**PLAN COMMISSION MEETING
IN PERSON AND VIA ZOOM
TUESDAY, NOVEMBER 4, 2025 – 6:30 PM
CITY HALL – SECOND FLOOR**

SITE PLAN REVIEW REPORT TO THE PLAN COMMISSION

PROPERTY ADDRESS: 1200 Industrial Dr.

FILE NUMBER: SPR-2025-29

ISOMETRIC VIEW
SCALE: 1/4" = 1'-0"

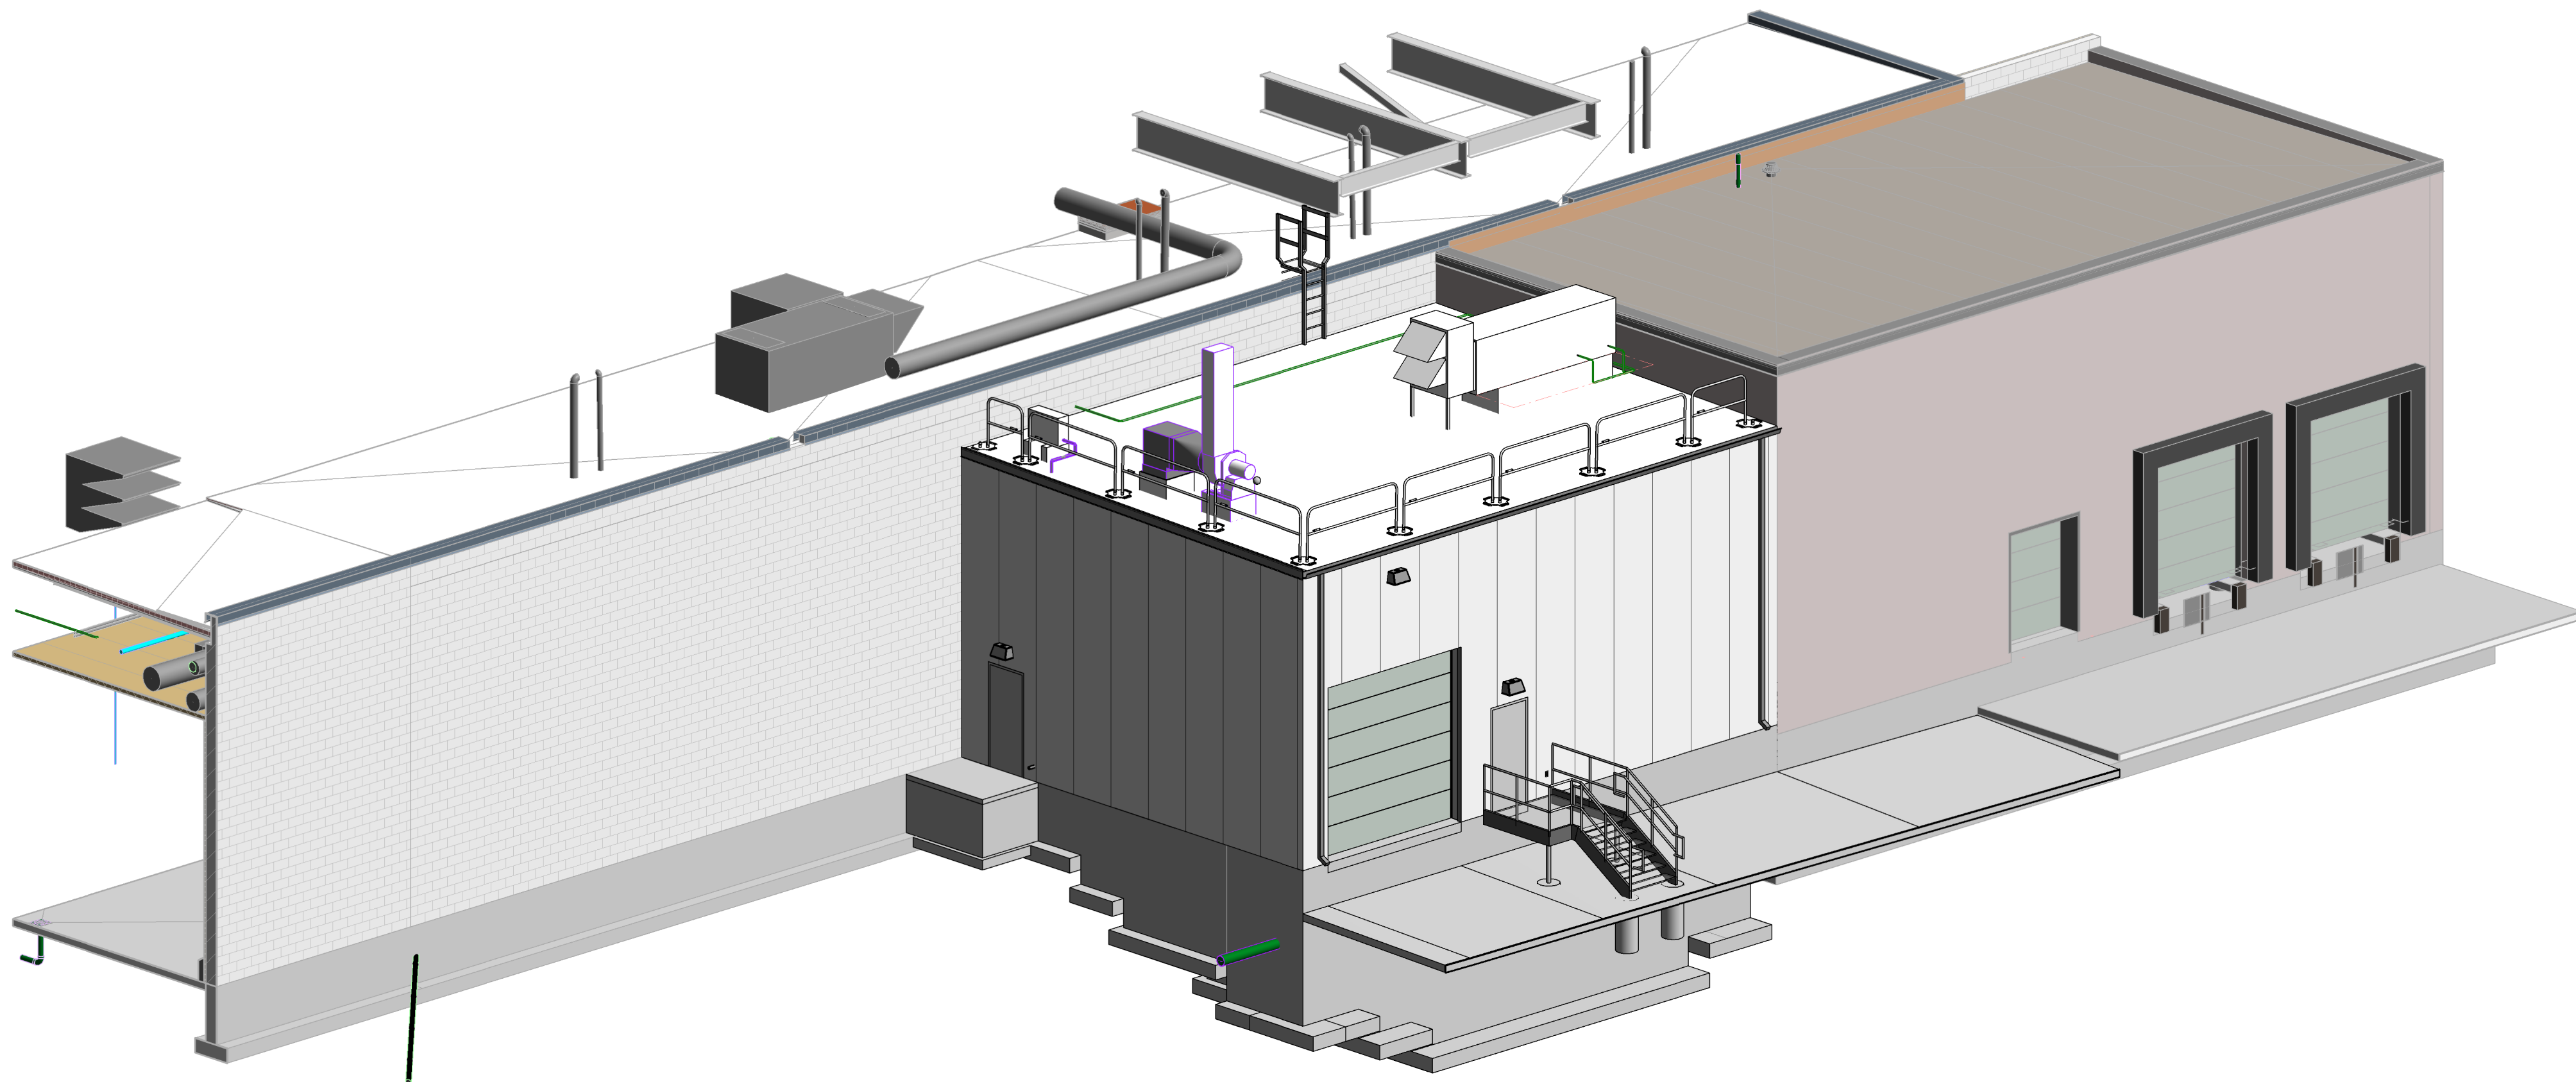
Per Section 15.07.01(2)(b), additions shall match or be substantially similar to the design and materials of the existing building = met (metal wall paneling)

CIVIL EXISTING SITE AND DEMOLITION PLAN

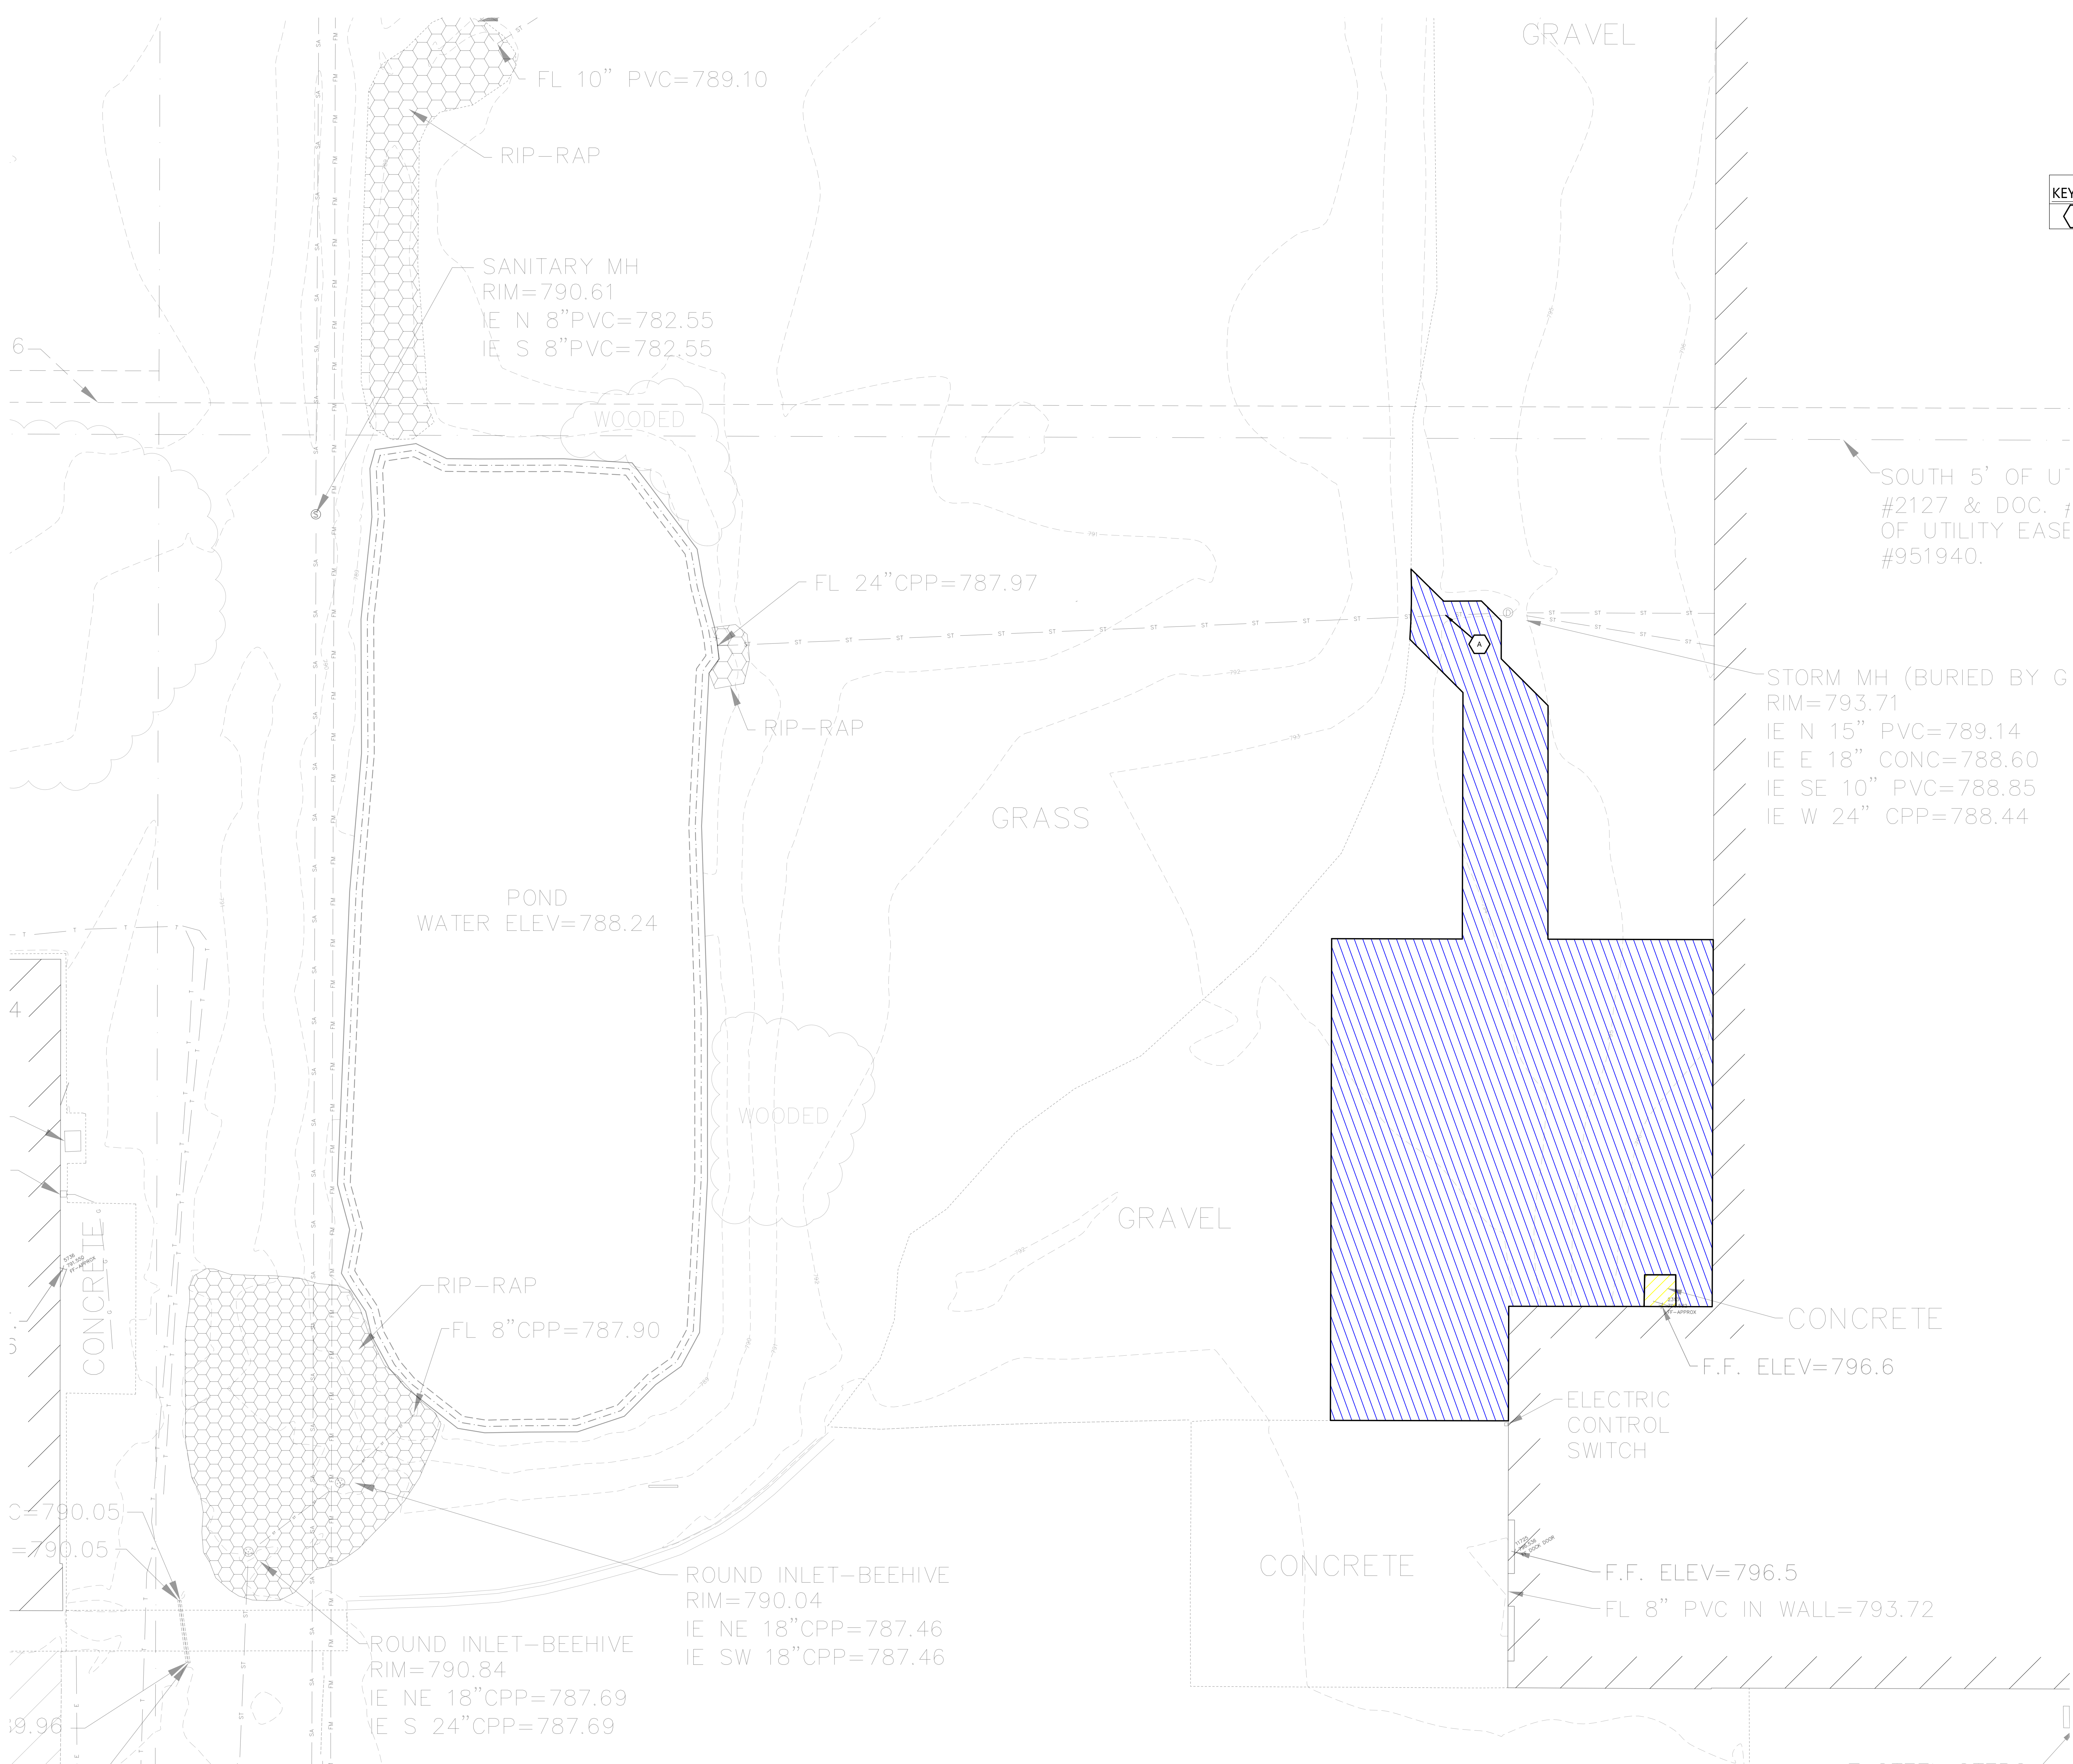
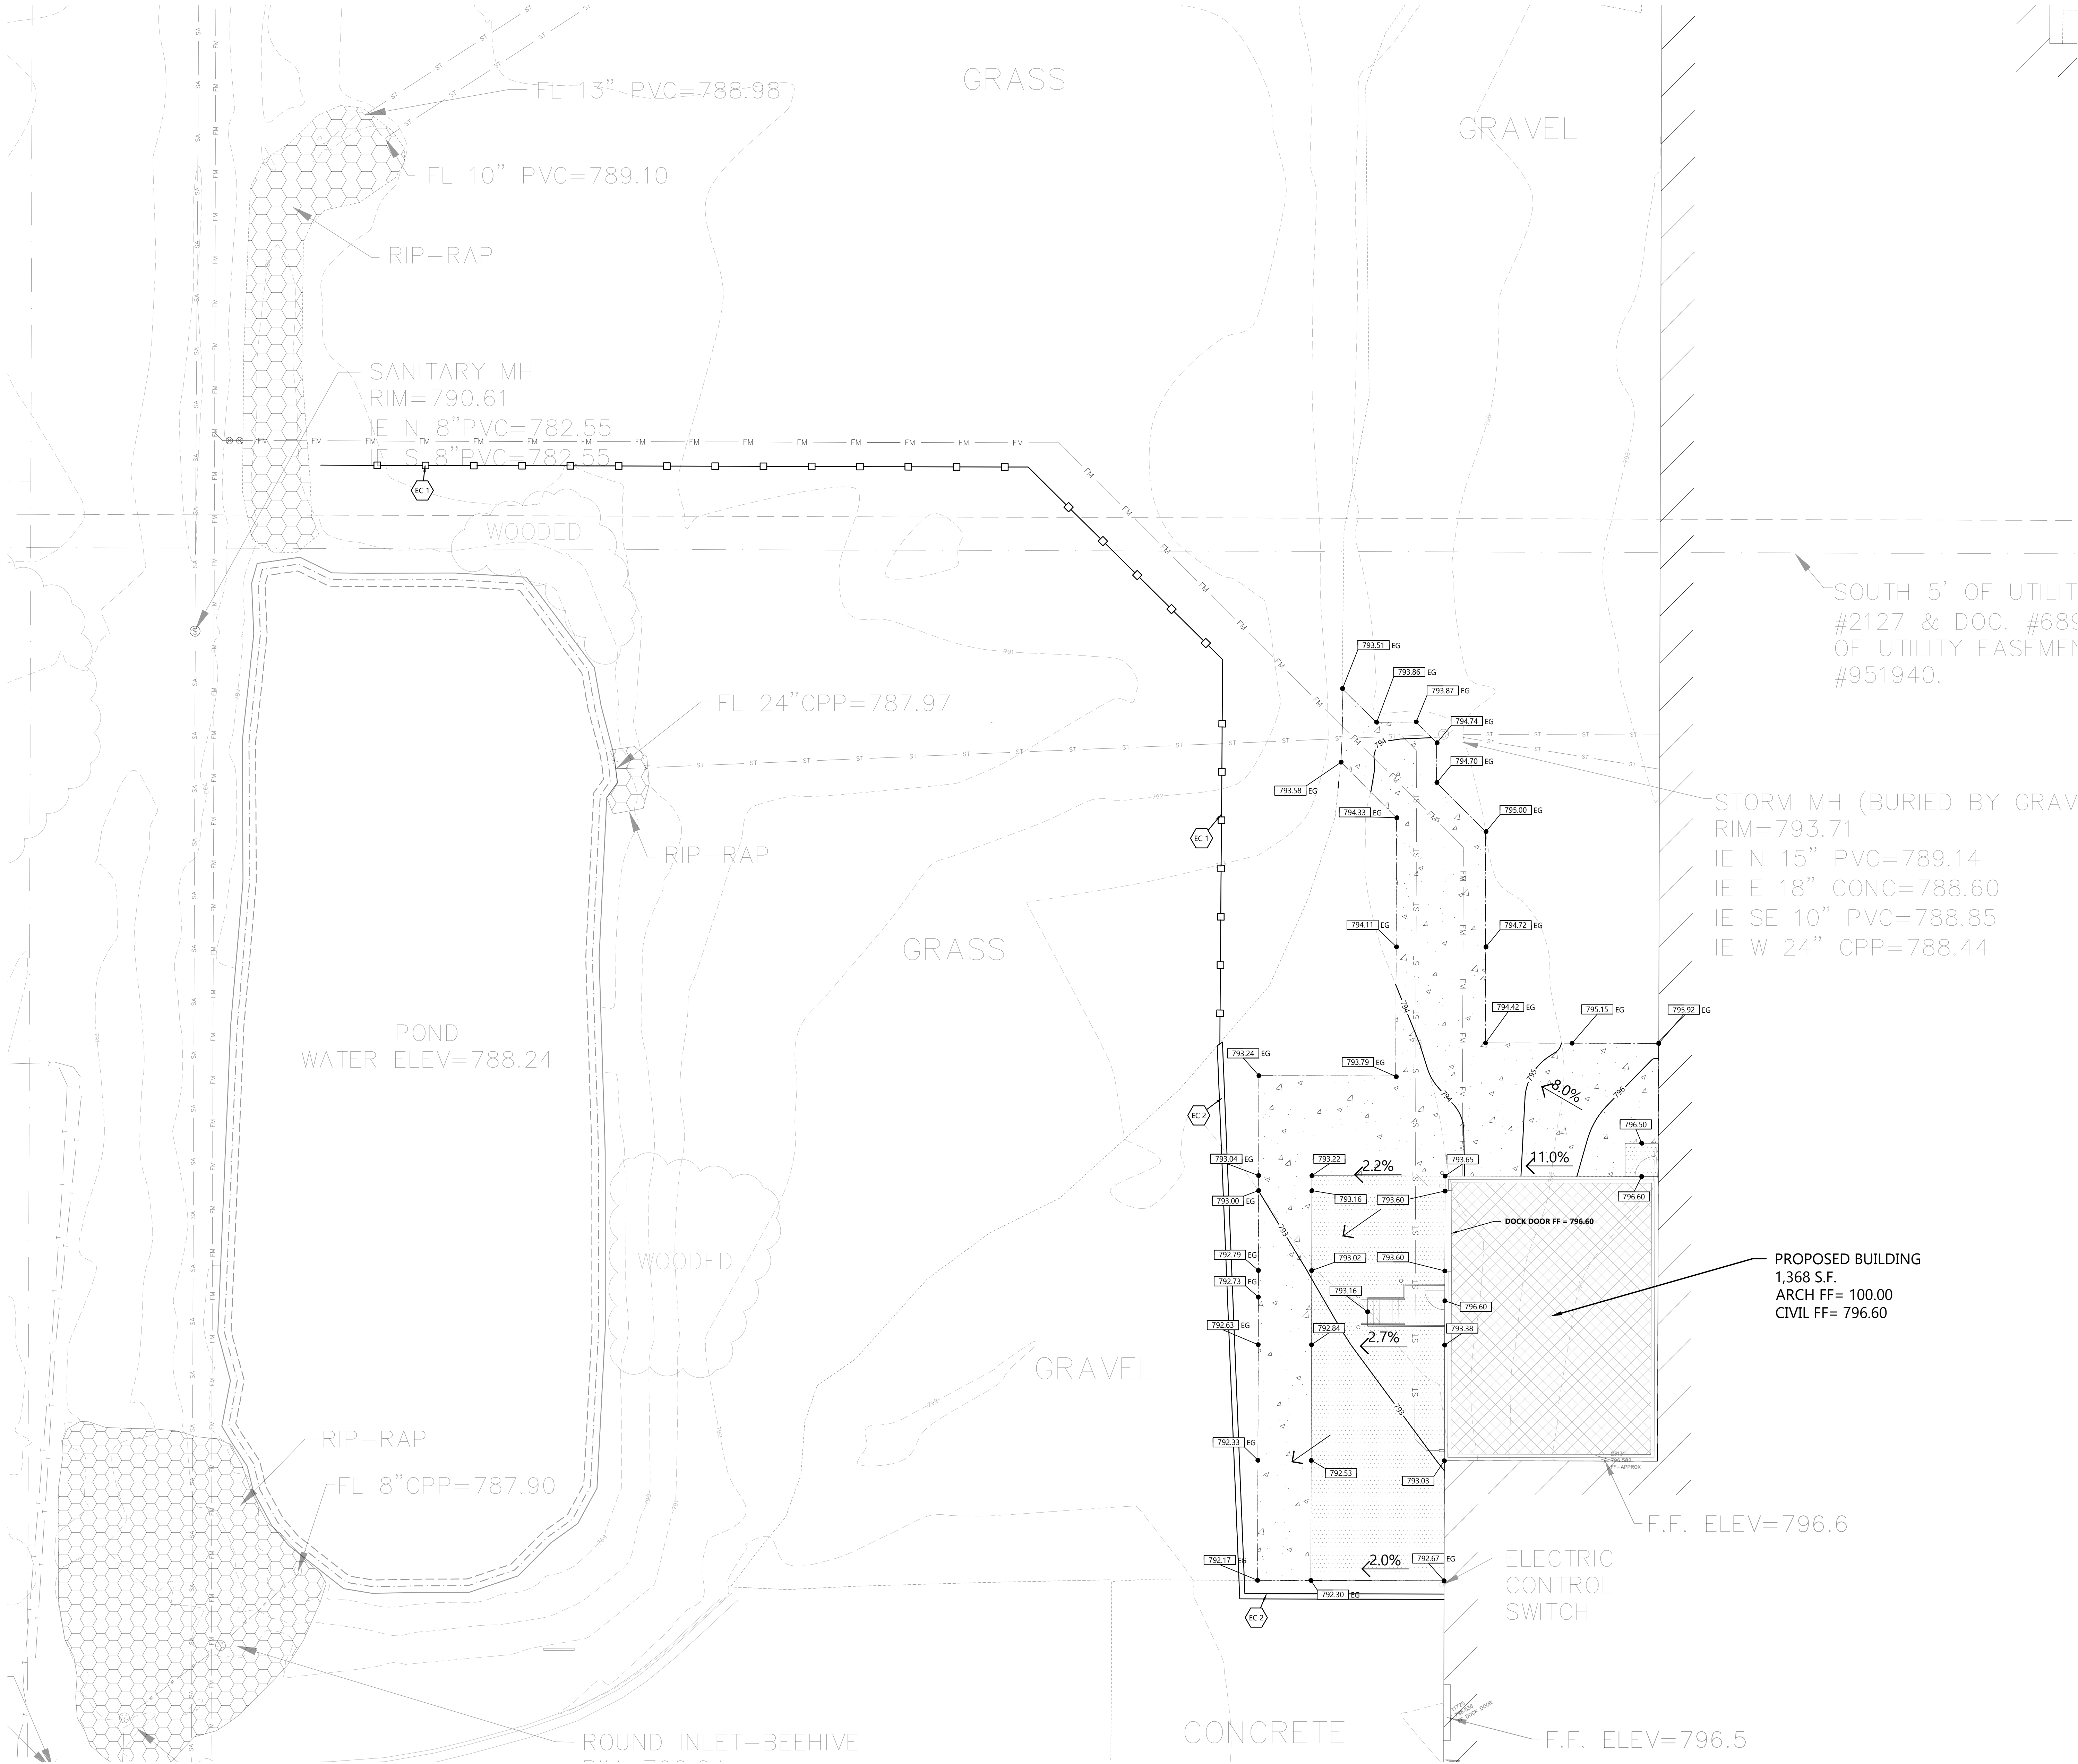
- No change proposed. No requirements are applicable to this project.
 1. There is approximately 40' between the proposed building addition and existing edge of the gravel driveway. This provides adequate space to move vehicles around the building addition within the existing, internal gravel driveway.
 2. There is approximately 70' between the front of the proposed building addition and the existing edge of the gravel driveway. This provides adequate space to conduct loading/unloading within the existing, internal gravel driveway.

- 0 landscaping points are required for the street frontage = Not applicable
- 0 landscaping points are required for the paved surface areas = Not applicable
- 23 landscaping points are required for the building foundation = **Not Met (none provided)**
- 14 landscaping points are required for the yards = **Not Met (none provided)**

to locate building foundation landscaping points surrounding the structure because of the design and existing surrounding impervious surfaces. An alternative location on the site could be utilized to satisfy the landscaping requirements and the total point value required (37 points) could be met through the addition of one canopy tree on the site. The Plan Commission can determine if the point values required could be met in an alternative location of the site.

The proposed project does not create additional impervious surfaces and does not require additional storm water management. It should be noted it has been observed that there are erosion control concerns with the ditches, culverts, and aprons on the site, resulting from stormwater runoff and current maintenance practices. The use of grass and weed control chemicals in the ditches has contributed to erosion and requires repairs to the ditches and aprons.

- Provide required Landscaping points in an alternate location in the Front or Street Yard.
- Parking areas to be paved in an approved method or cease to be used for the parking of vehicles or semi-trailers.
- Raise the existing Stormwater manhole to the new grade.
- Restore existing ditches and aprons damaged by stormwater leaving the site.
- Any other comments by the Plan Commission.
